CASE NO. FP-2026-0001

**ORDER OF CONDITIONAL
APPROVAL OF FINAL PLAT**

SUBJECT: Apex Cadence No. 1 – FP
FP-2026-0001

Final plat consisting of 112 building lots and 27 common lots on 5.10 acres in the R-15 zoning district for the first phase of Apex Cadence Subdivision.

PLAT OF APEX CADENCE SUBDIVISION No. 1

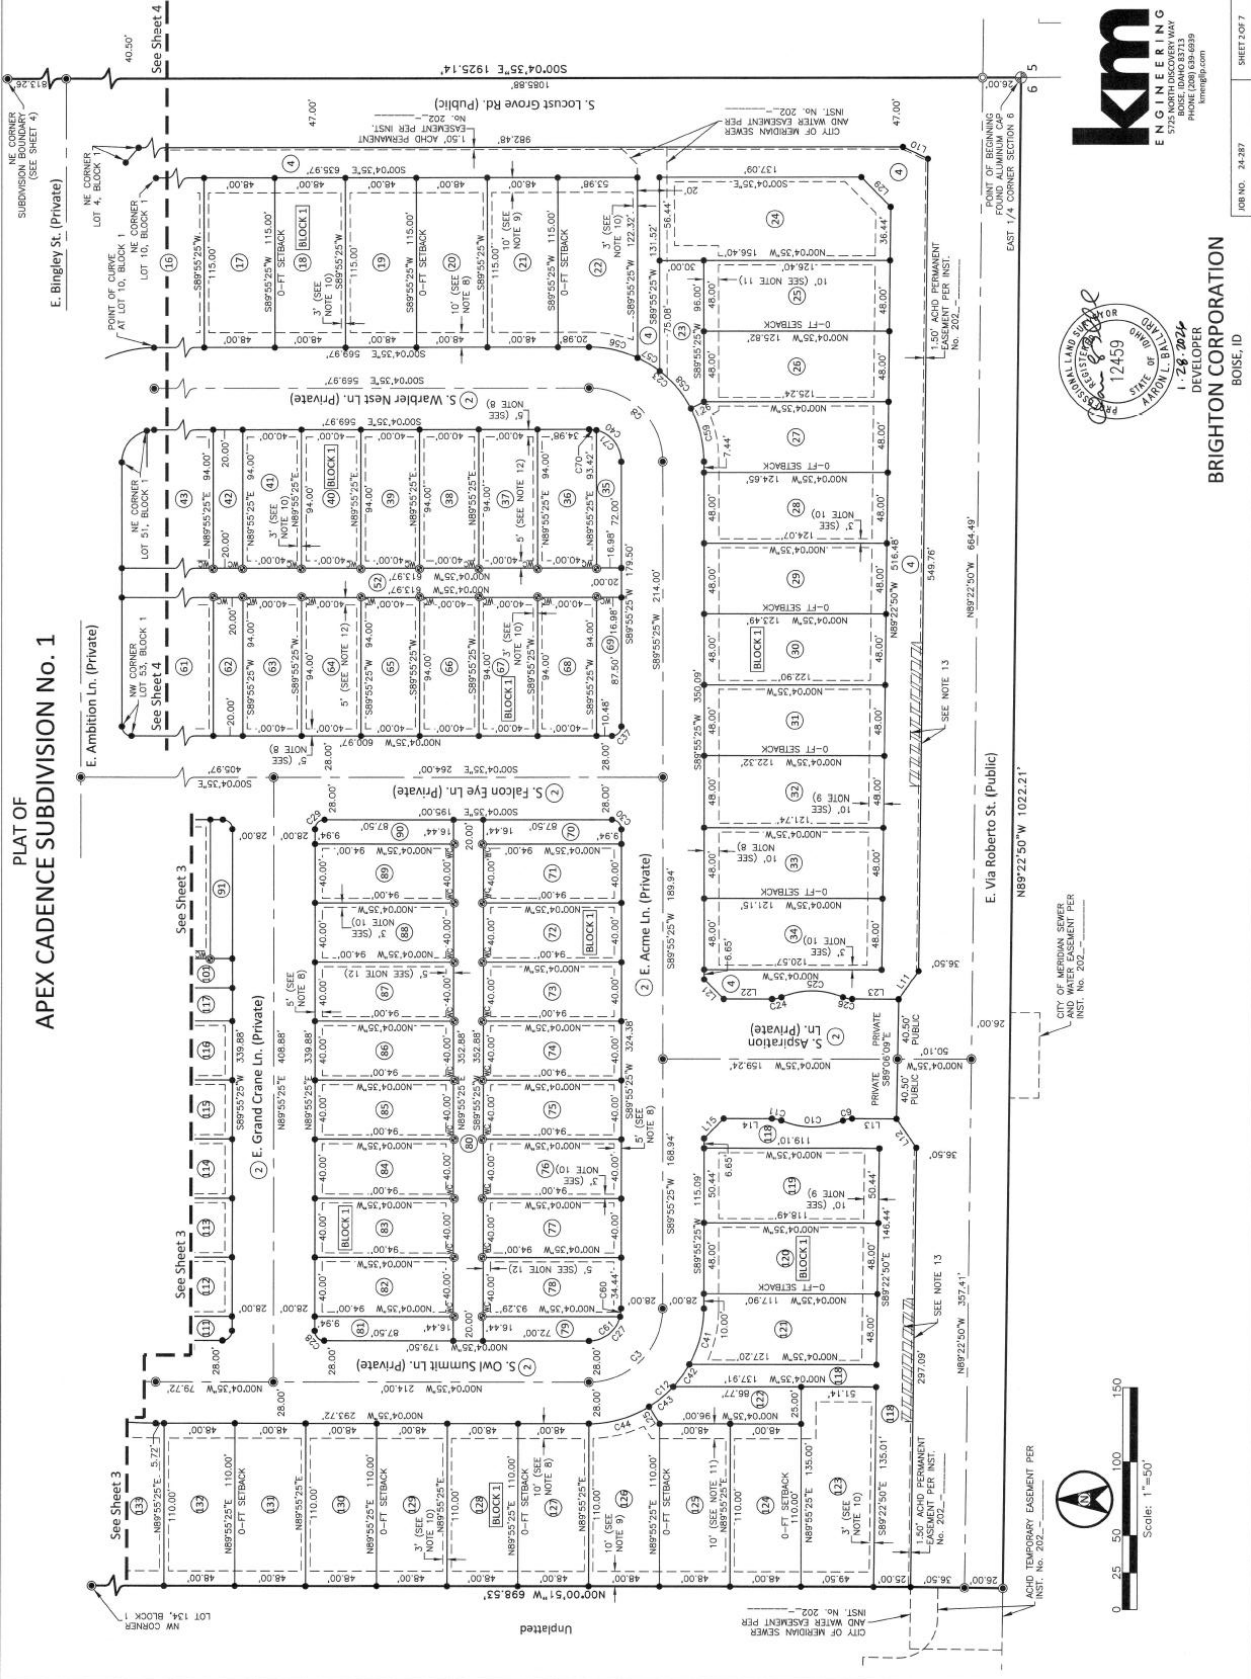
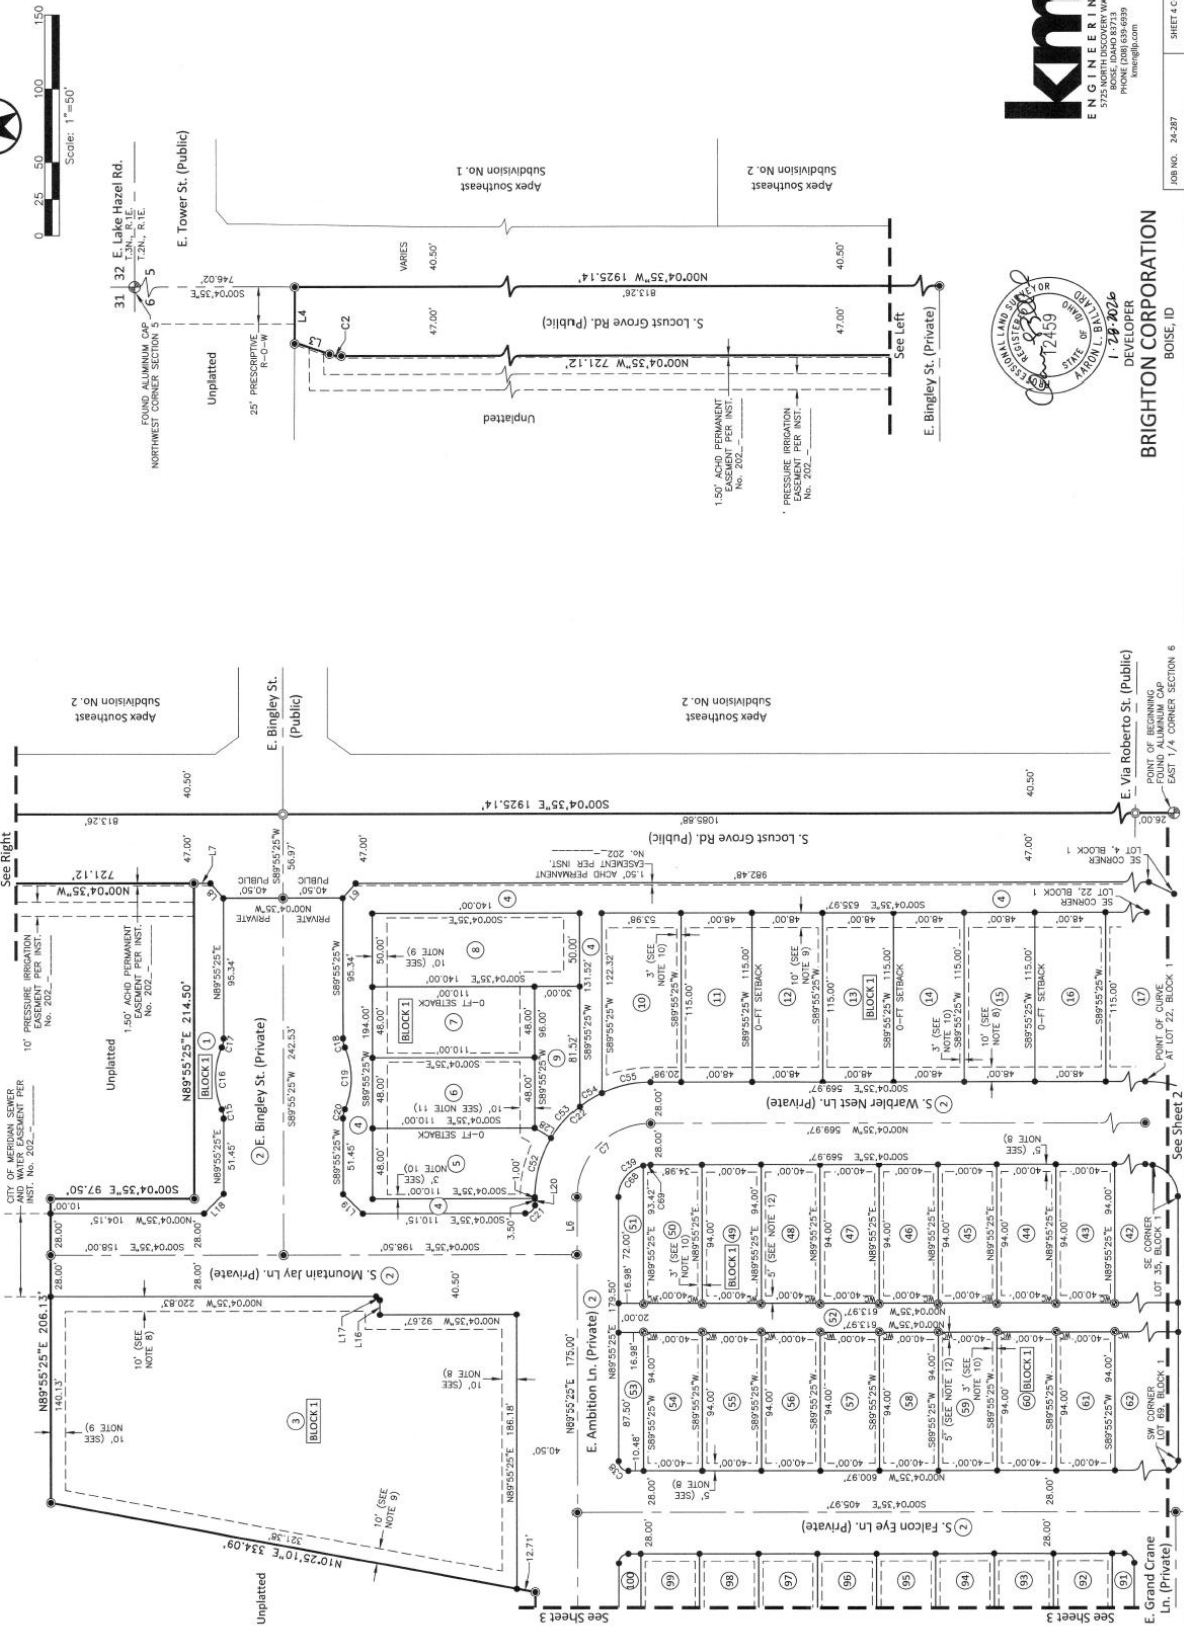
3. Prior to submittal for the City Engineer's signature, have the Certificate of Owners and the accompanying acknowledgement signed and notarized.
4. The final plat prepared by KM Engineering, dated: 01/28/2026, included in Section V.B shall be revised as follows:

- a. Note #5: Lot 136 should be Lot 135, Block 1
 - b. Note #6: Include that the private street shall provide perpetual ingress-egress to all lots in the subdivision.

- c. Note #7: Lot 123 should be 122; and Lots 124, 125 & 126 should be 123, 124 & 125
 - d. Note #11: Lot 123 should be 122
 - e. Note #14: Include the recorded instrument number of the ACHD temporary license agreement

- f. Include the recorded instrument number of the City of Meridian sewer and water easement graphically depicted on Sheets 2, 3 and 4.
 - g. Include the recorded instrument number of the ACHD permanent easement graphically depicted on Sheet 2, 3 and 4.

- h. Include the recorded instrument number of the 10' pressure irrigation easement on Sheet 4.
 - i. Depict a 14-foot wide public use easement for the multi-use pathway along the Rawson Canal on Lot 135, Block 1 outside of the irrigation easement unless permission is specifically obtained from the governing irrigation district; include the recorded instrument number of the easement on the plat.

- j. If the multi-use pathways/sidewalks along E. Via Roberto St. and S. Locust Grove Rd. aren't located entirely within the right-of-way, public use easement(s) shall be depicted on the plat.

- k. Depict a minimum 10-foot-wide multi-use pathway along the Rawson Canal in Lot 135, Block 1 in accord with UDC 11-3A-8G and the Pathways Master Plan.

- l. Depict the easement for the Watkins Drain.

A copy of the revised plat shall be submitted with the final plat for City Engineer signature.
5. The landscape plan prepared by KM Engineering, dated 01/30/2026, included in Section V.C, shall be revised as follows:
 - a. Depict enhanced landscaping within the street buffers along S. Locust Grove Rd., an arterial street, and E. Via Roberto St., a collector street, in accord with the standards listed in UDC 11-3B-7C. and 11-3G-3B.3. Include a note stating what the enhanced landscaping consists of.

APEX CADENCE SUBDIVISION NO. 1
MERIDIAN, IDAHO
LANDSCAPE CONSTRUCTION SET
FENCE PLAN

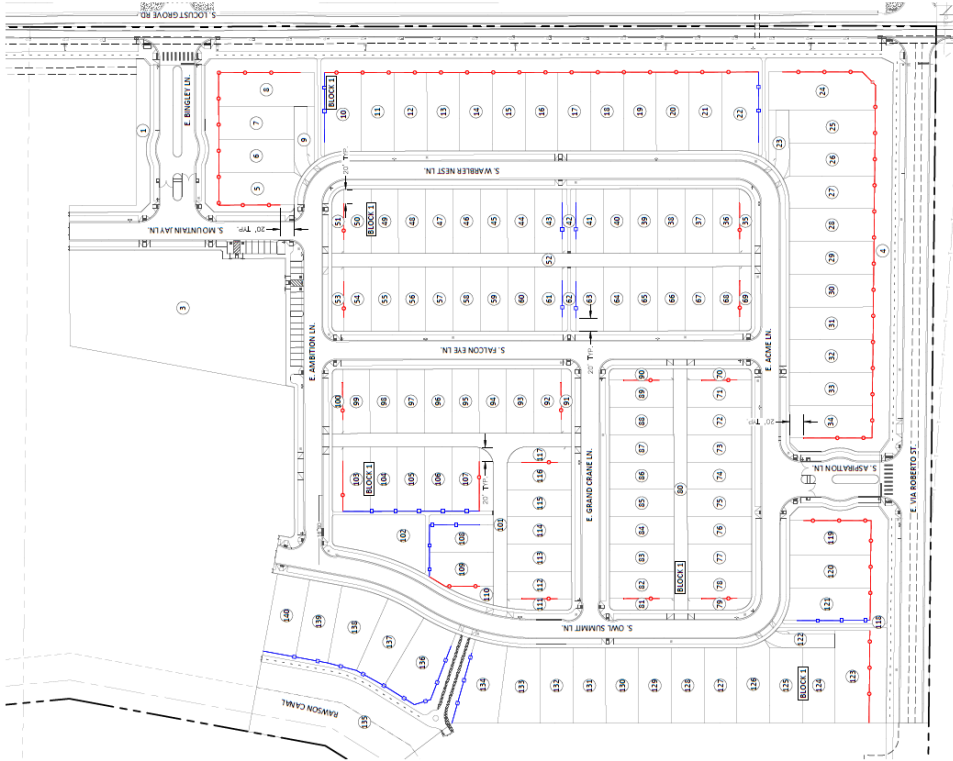
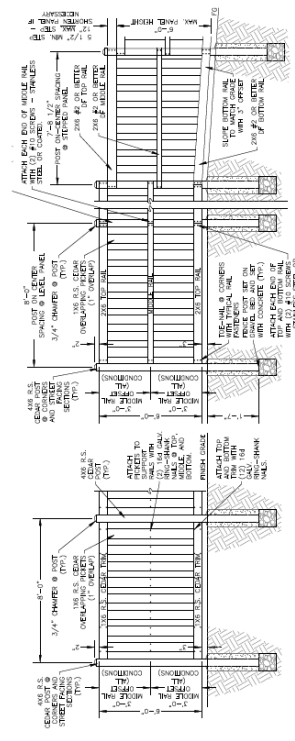
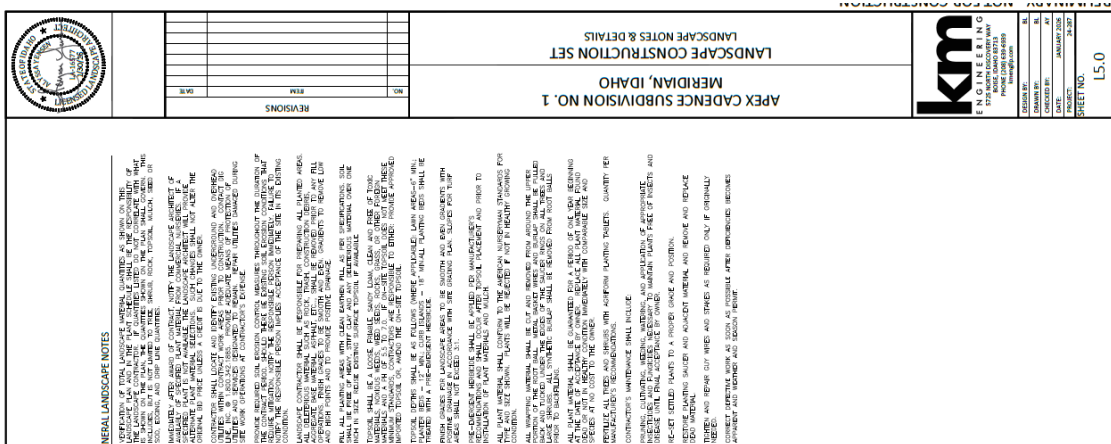
- b. Include calculations for the required number of trees within the parkways along internal private streets that demonstrate compliance with the standards in UDC 11-3A-17E, 11-3B-7C and UDC 11-3G-3B.4.
- c. Widen the multi-use pathway to 10-feet along the Rawson Canal in Lot 135, Block 1 in accord with UDC 11-3A-8G and the Pathways Master Plan.
- d. Widen the detached sidewalks to 10-feet within the street buffers along S. Locust Grove Rd. and E. Via Roberto St.
- e. Include tree mitigation calculations on the landscape plan in accord with the standards in UDC 11-3B-10C.5, as applicable.
- f. Depict a minimum 5-foot wide landscape strip on each side of all pathways as set forth in UDC 11-3B-12C.1; or submit an application for alternative compliance to this standard.

A copy of the revised landscape plan shall be submitted with the final plat for City Engineer signature.

E. Common Driveway Exhibits – **NOT APPROVED**

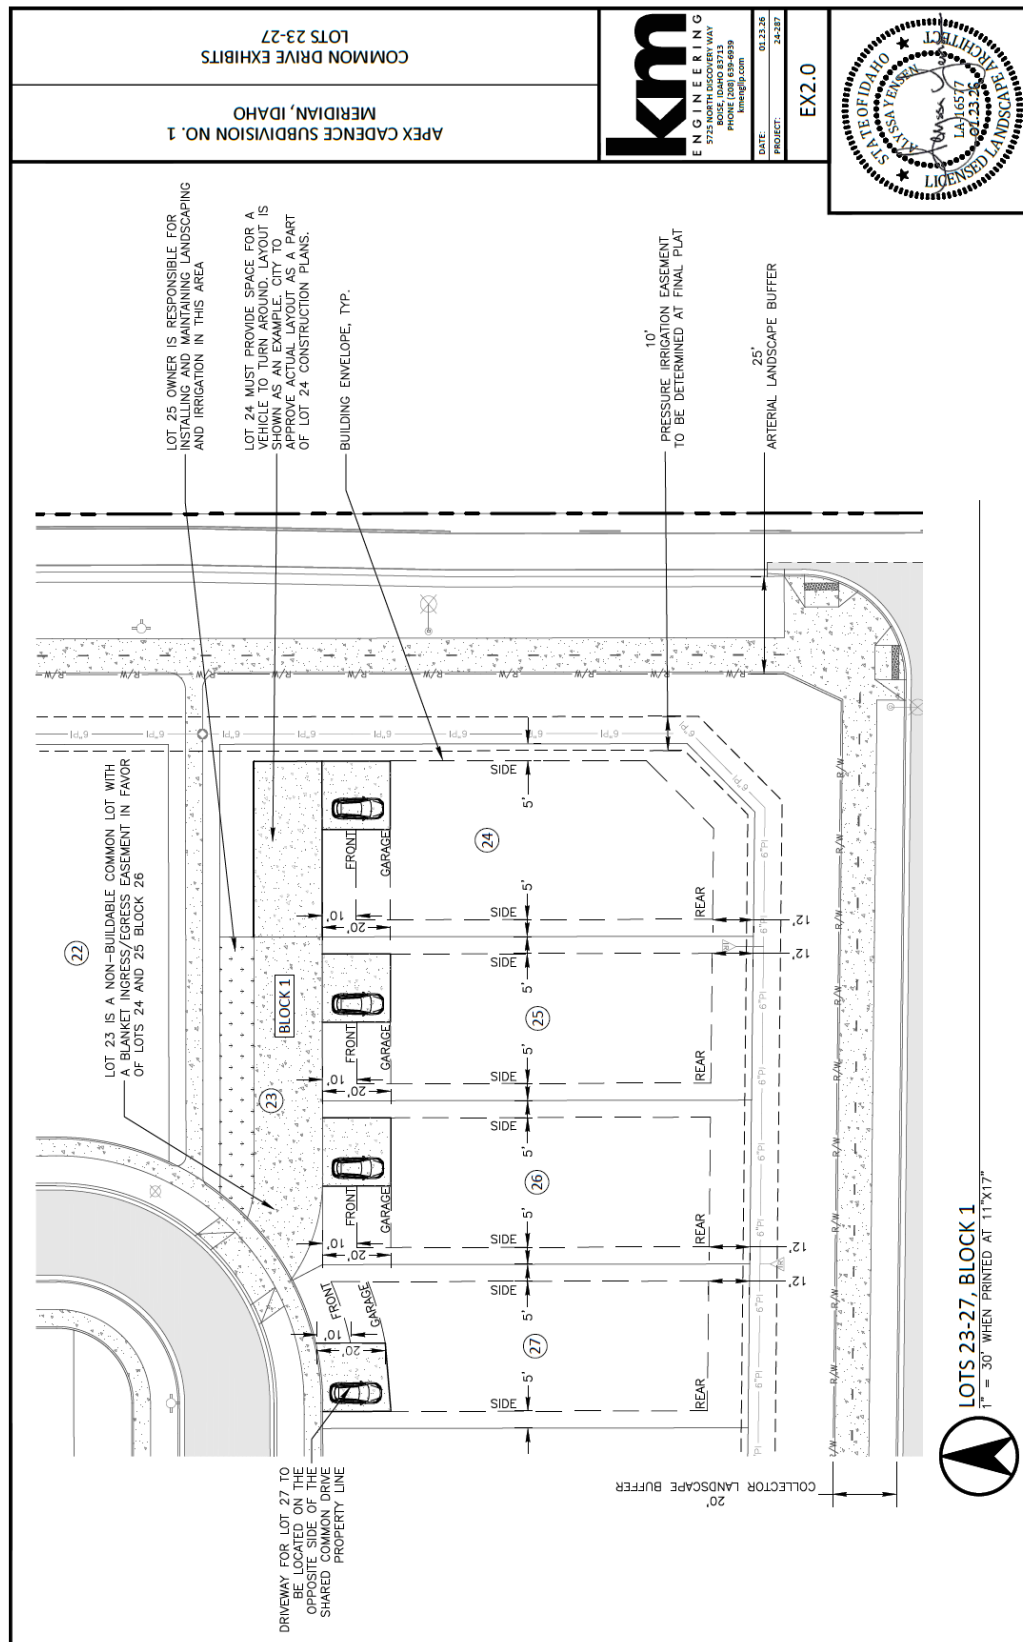
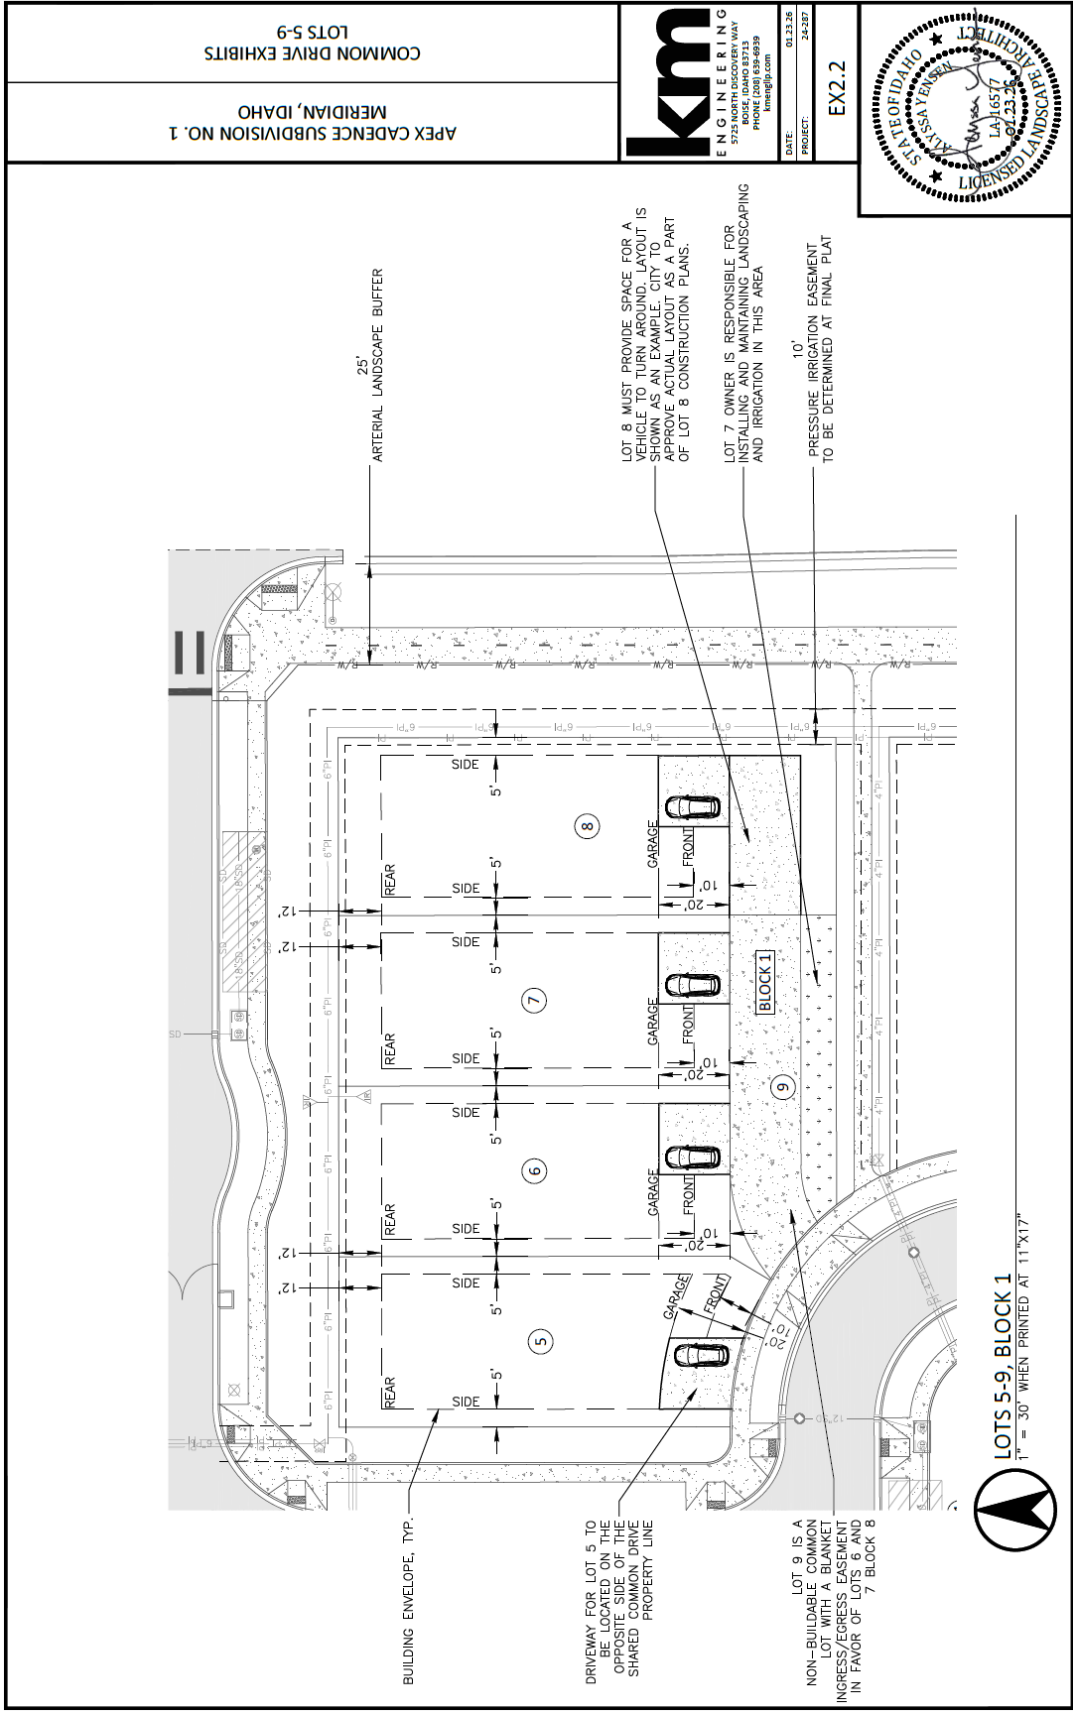
20. The common driveways on Lots 9, 23 and 122, Block 1 shall be constructed in accord with the standards listed in UDC 11-6C-3D. **The common driveway exhibits included above in Section V.E shall be revised as follows: delete the note requiring the property owner to install and maintain landscaping and irrigation in the landscape area along the common driveway – the developer is responsible for installing irrigation and landscaping in these areas and the Homeowner’s Association is responsible for maintaining these areas.**
